A G E N D A

Architectural Review Board

February 23, 2016

655 Hubbard Street

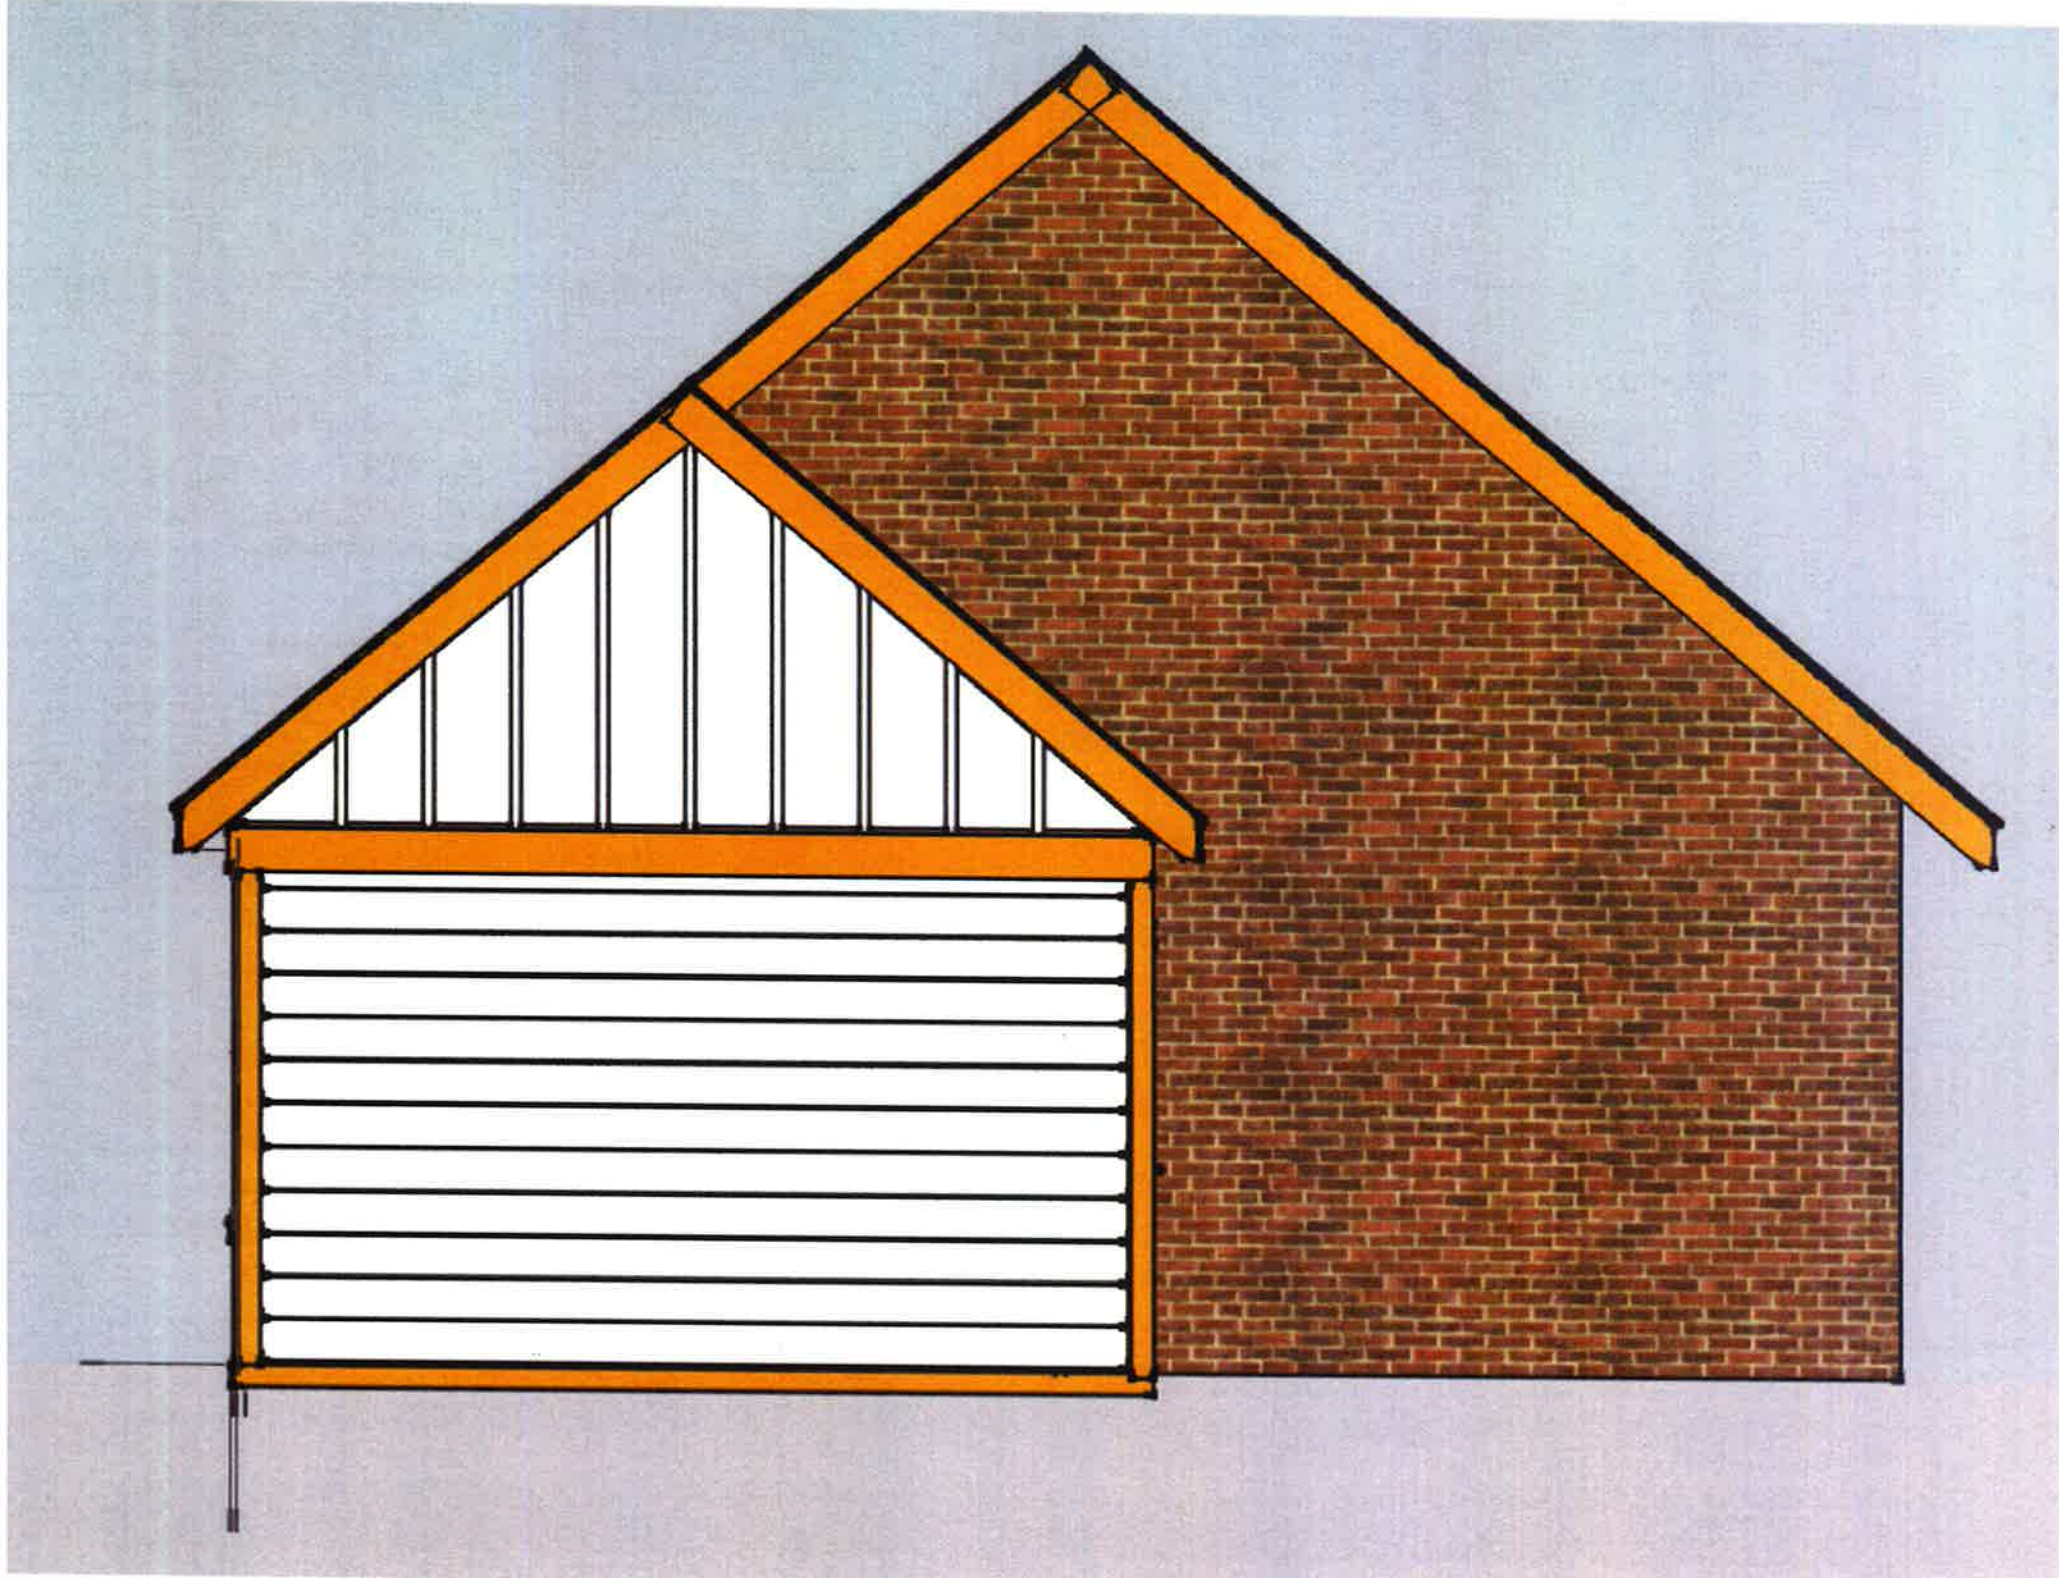
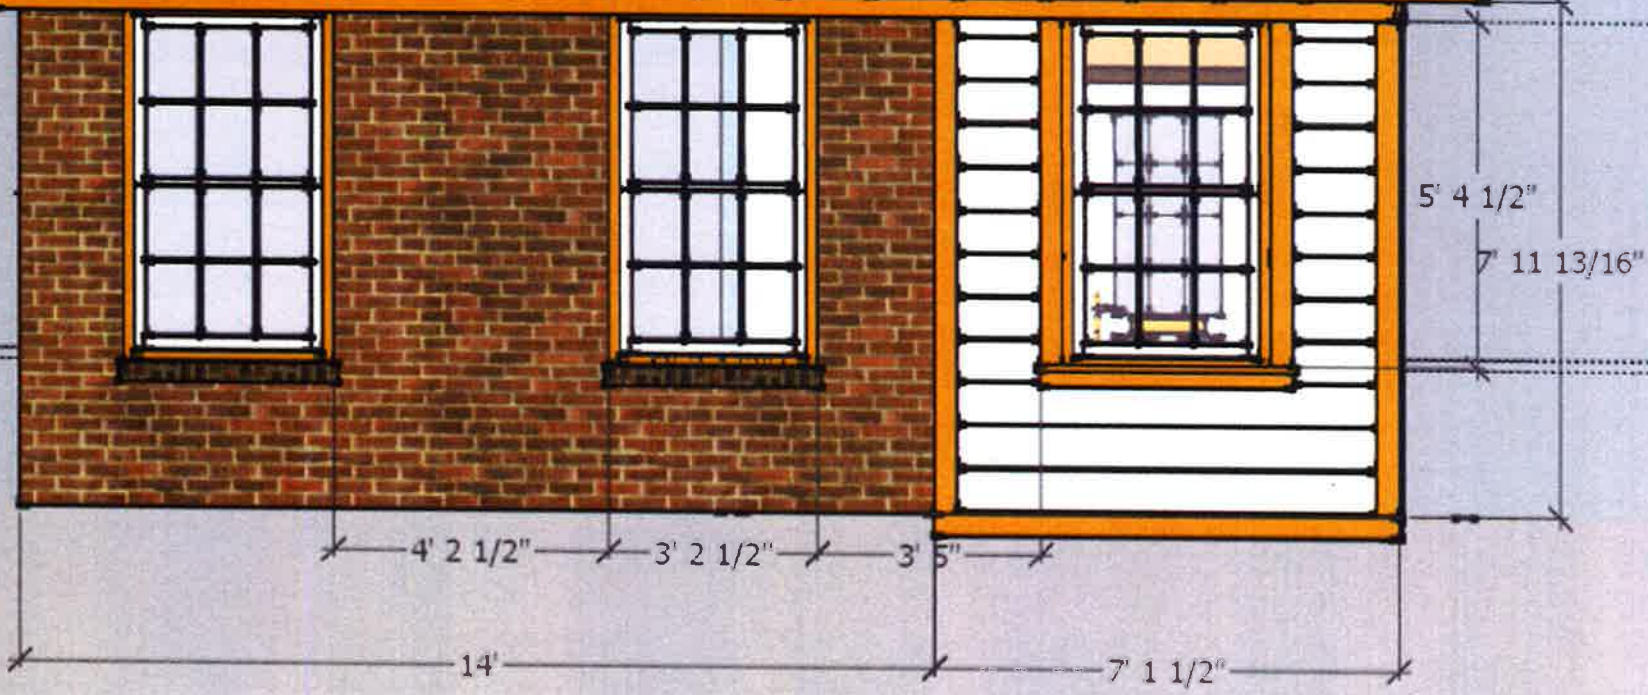
- The Board has previously approved the enclosure of side porches that have been set back from the front plane of the house.
- The Board denied the enclosure of a side/front porch where the porch made up half of the front elevation.
